1 MONTPELIER SQUARE, LONDON SW7

Document **MINOR MATERIAL AMENDMENT
DESIGN & ACCESS STATEMENT**

Revision **A**

Issue Date **09.04.2024**

Fig. 2.2: Section of Proposed Scheme

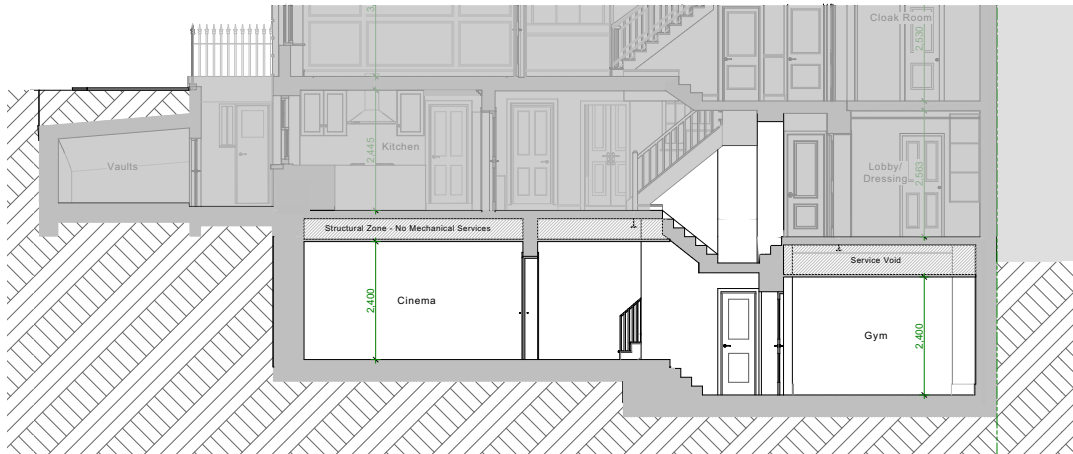
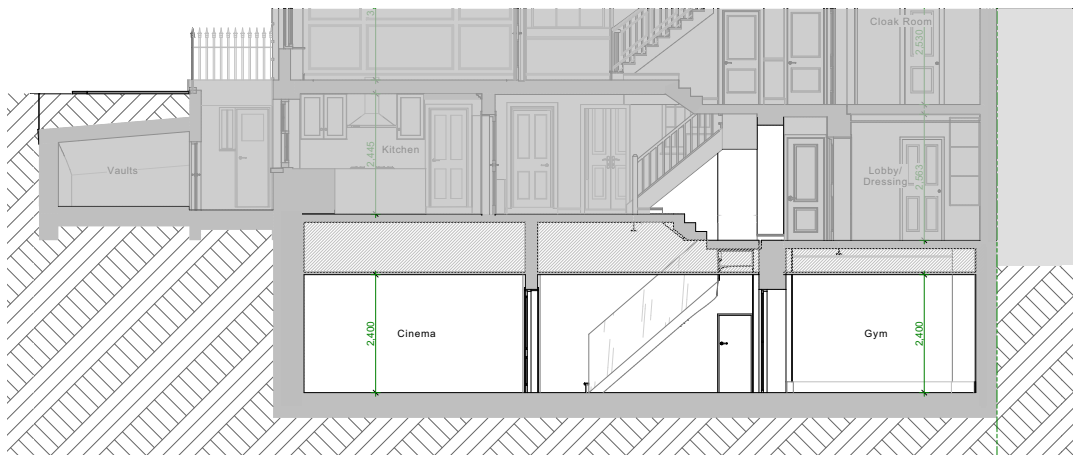
The proposed amendment to the consented scheme relates to the basement floor level. The proposals outlined in this statement seek to level the floor throughout the new basement.

These proposals will not be visible from outside the property. These proposals will not increase the area of the scheme. These proposals will not impact any of the retained fabric of the heritage asset.

These proposals will not increase the finished floor-to-ceiling height in any way from the consented scheme.

Fig. 3.2: Partial Floor Plan of Proposed Scheme

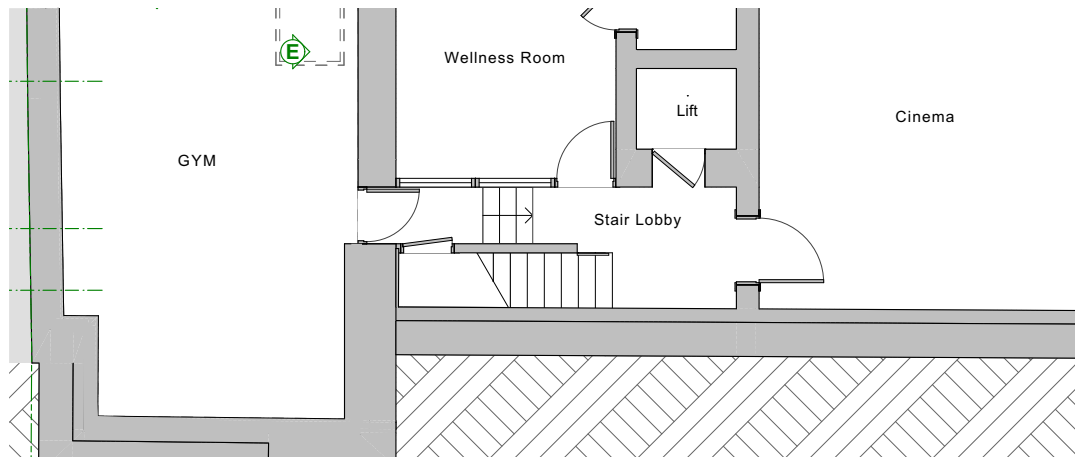
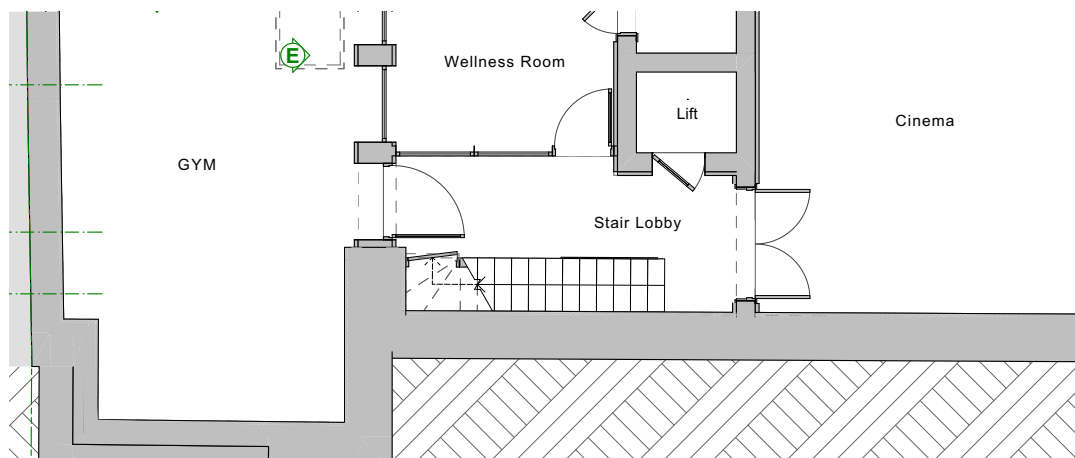
These proposals revolve around removing the split level in the basement, so the entire floor can be accessible by the lift.

While not all areas of the house will have level access from the lift landings, the design team asserts that the basement is an entirely new floor and should have level access.

As well as the amendment to remove the internal basement steps & level the floor, this application also seeks the de minimis changes to the doors to the cinema and gym. With the gym door to increase in size, and the cinema door to increase to a double-door. The revised design also pushes back the wall to the wellness room and removes the wall between the main stair and the lobby.

(Please refer to Figures 3.1 & 3.2) The steps to join the split levels currently compromises the door to the wellness room. In order to accommodate a landing at the bottom of these steps, the door to the gym had to be smaller. And the door to the wellness room became uncomfortably close to the top step. Removing these steps & split level would resolve these issues.

Fig. 3.3: Section E-E of Approved Scheme (23/03312/FULL)

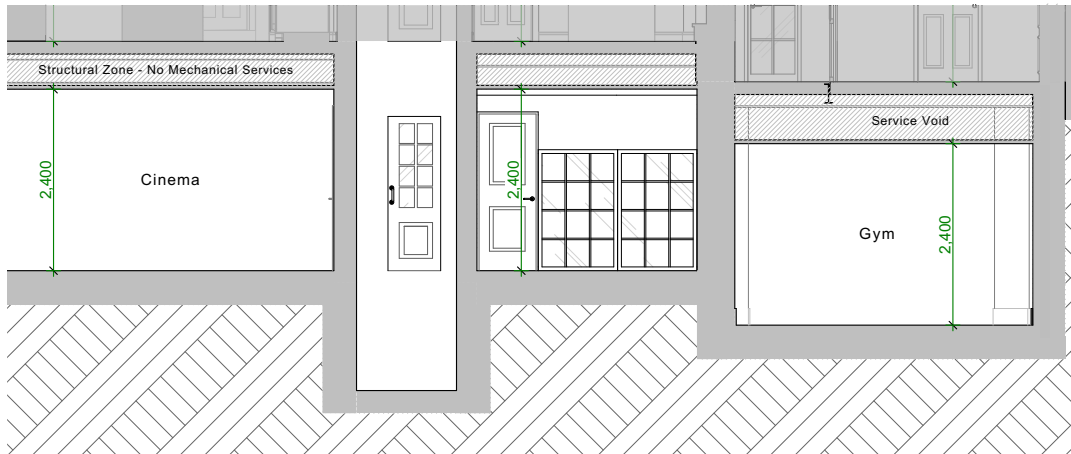
One impact of the split levels that was not realised during the original planning process, was how it would compromise the glazed partition into the wellness room. (Please refer to Figures 3.3 & 3.3.) By raising the floor level below the main body of the house, the glazed partition becomes uncomfortably low.

As shown in figures 3.5 & 3.6, removing the level change in the basement and lowering the floor level below the main body of the house allows the height of the glazed partition to match that of the door into the wellness room. This is a much more elegant solution than the consented scheme has space for.

Fig. 3.8: Plan of now proposed basement

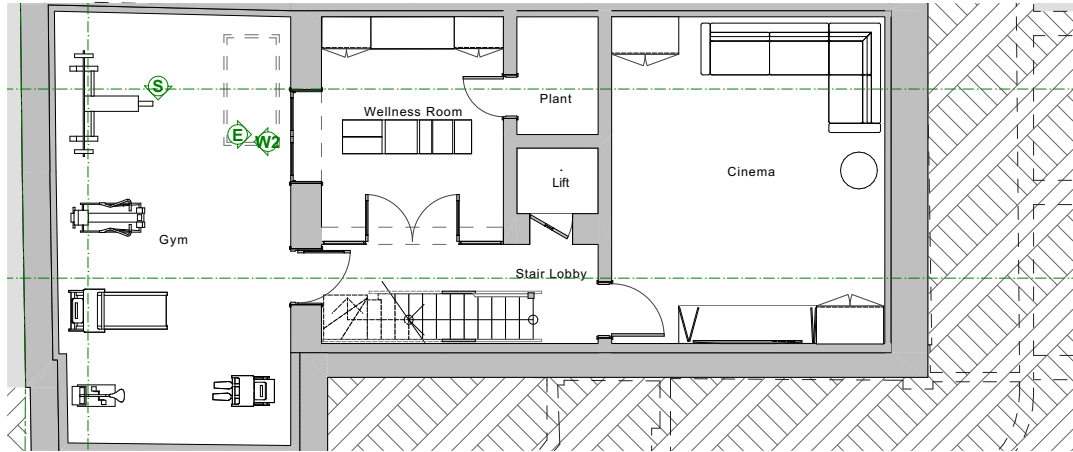
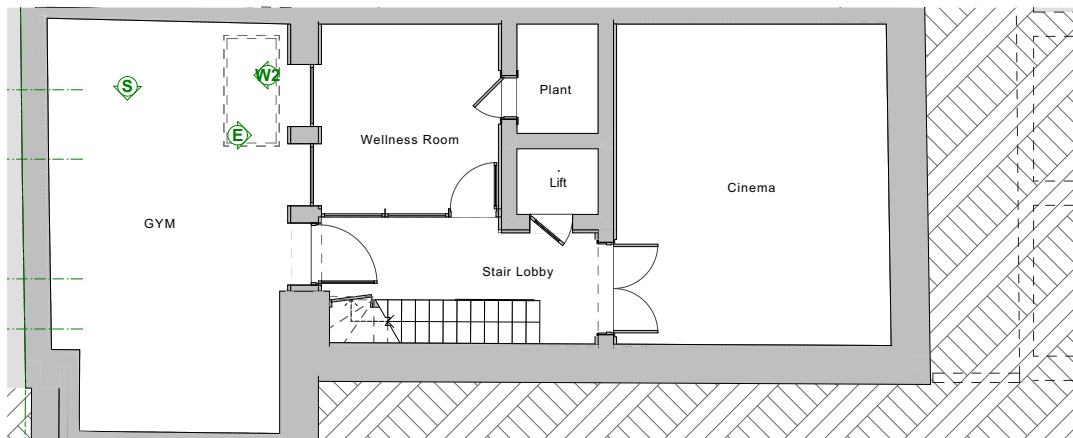
Removing the level change allows for the reintroduction of the internal windows between the wellness room and the gym. (Please refer to figure 3.7 overleaf.) This feature was originally proposed to bring natural light from the lightwell skylight in the gym into the wellness room.

When the split level was introduced, the internal window between the wellness room and the gym was omitted. This decision was made as the internal window was incongruent with the different levels of the rooms, with the window head becoming uncomfortably low in the wellness room (the head would have been 1.6m above FFL).

Figure 3.7 shows the internal window between the gym and wellness room that featured in the original submission for 23/03312/FULL, that was later omitted in the consented scheme.

Removing the split level allows the windows to be reinstated. Figure 3.8 demonstrates the new proposed openings between the gym and the wellness room. The greater glazed openings allow for more light to enter the gym. The proposal has been developed in accordance with Evolve's structural calculations.

Fig. 3.12: Partial Floor Plan of Proposed Scheme

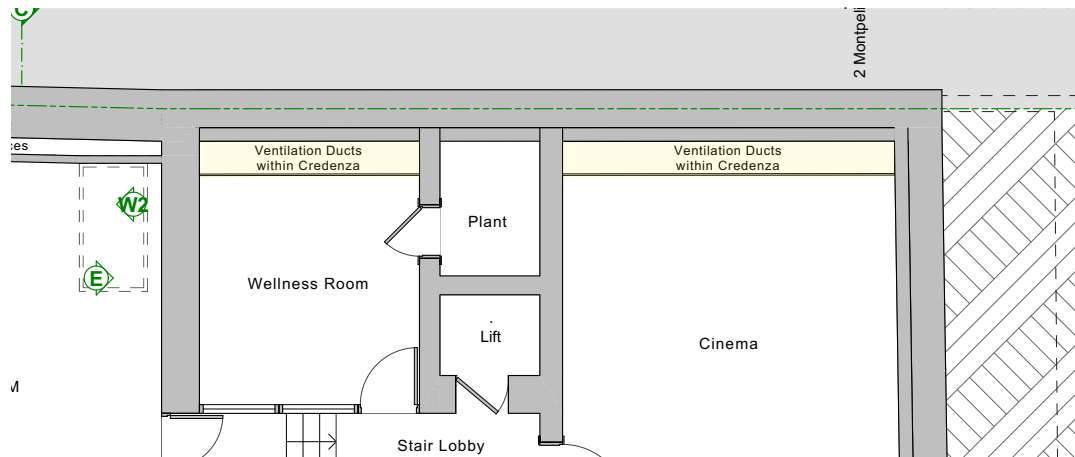
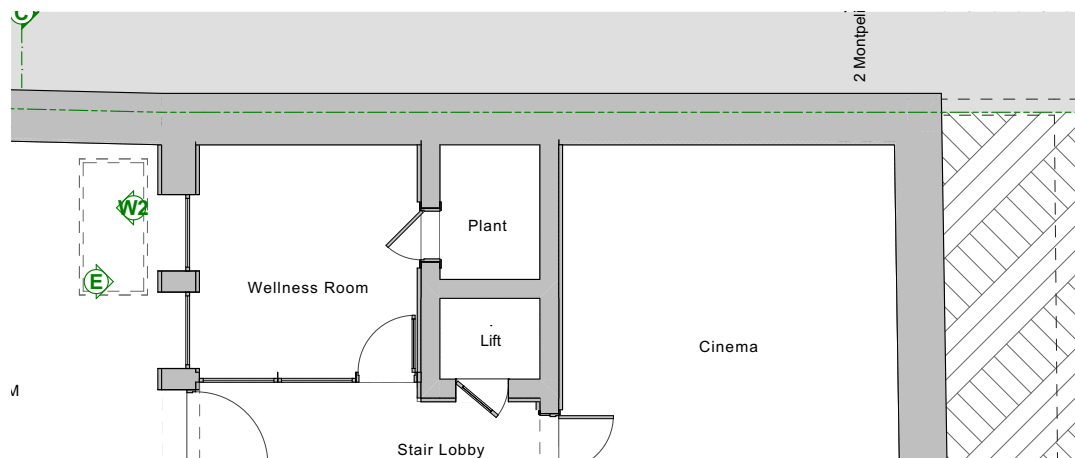
The consented scheme features ventilation ducts within in-built 'credenza' joinery units. As the basement does not have operable external windows, mechanical ventilation is required.

The omission of a mechanical services void in the Basement ceiling was 'solved' by bringing the ducts and grilles into fixed joinery pieces. However, doing so greatly reduces the efficiency of the ventilation system, and will require more energy to run.

The fixed joinery will also reduce the flexibility of the spaces in the basement, and reduce the overall available accommodation space.

Reinstating a services void above the proposed ceiling would remove the necessity for these fixed joinery pieces, and bring back flexibility to the basement spaces.

Fig. 3.14: Section of Proposed Scheme

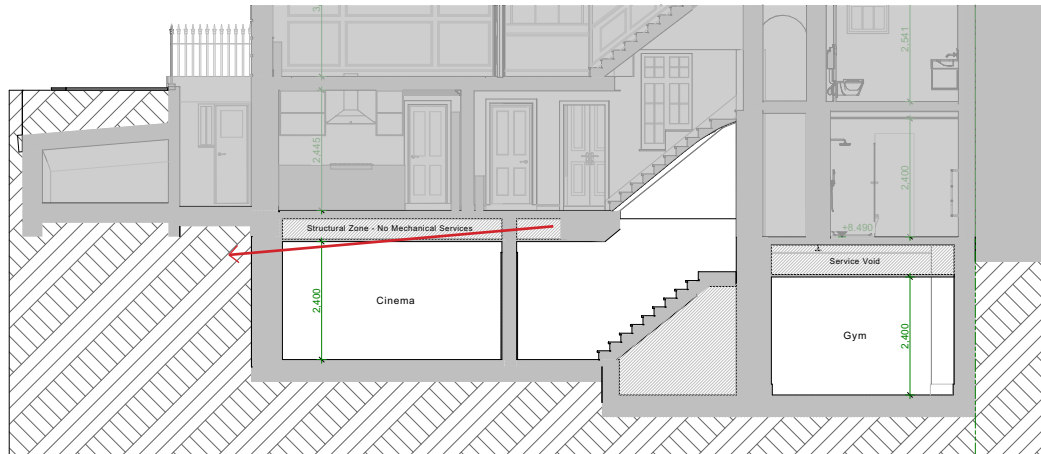
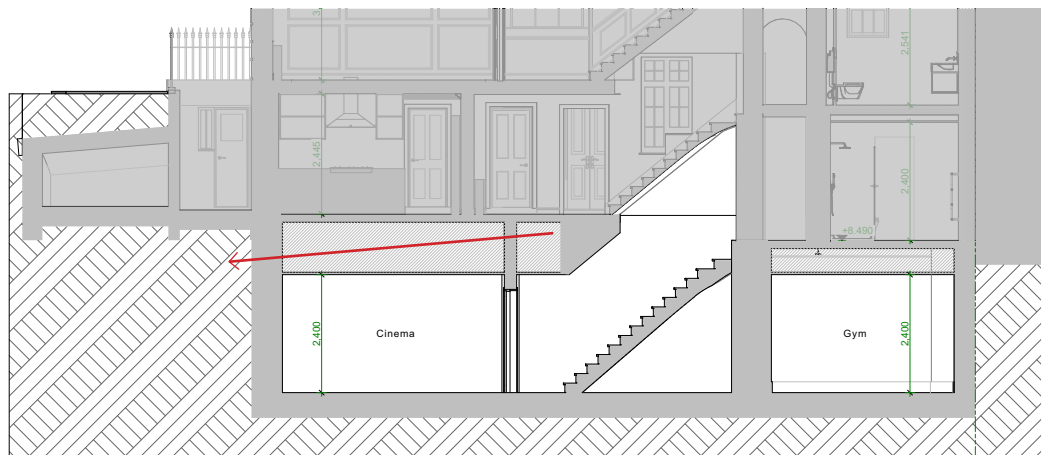
Another aspect of the design that was not fully realised during the planning process for 23/03312/FULL was the impact on drainage.

Omitting the mechanical service void from above the Basement Floor will severely compromise the ability to drain both rainwater and foul water.

As the basement is below the level of the existing drains, the revised drainage needs to be fed within a space between the Lower Ground Floor and the Basement. The omission of the mechanical service void will require additional pumping - which will introduce more points of potential failure to the system - or significantly impact the spaces in an undesirable manner.
